4.3 Inch Indoor Station Release Note

(2026-05-21)

Firmware Basic Information	Firmware Version	DS-KH6110-WE1：V2.2.116_build260427 DS-KH6100-E1&DS-KH6000-E1：V2.2.116_build260519
	Device Type	**B1Pro**：DS-KH6110-WE1 **B2**：DS-KH6100-E1，DS-KH6000-E1

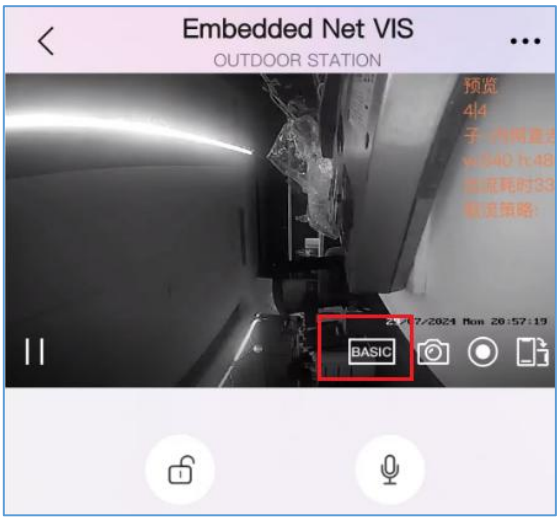
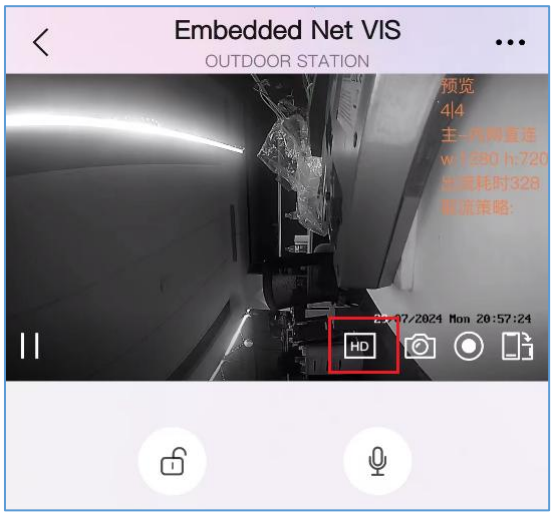
2. Support switching between main and sub stream (HD and Basic) when live view the door station from hik-connect app
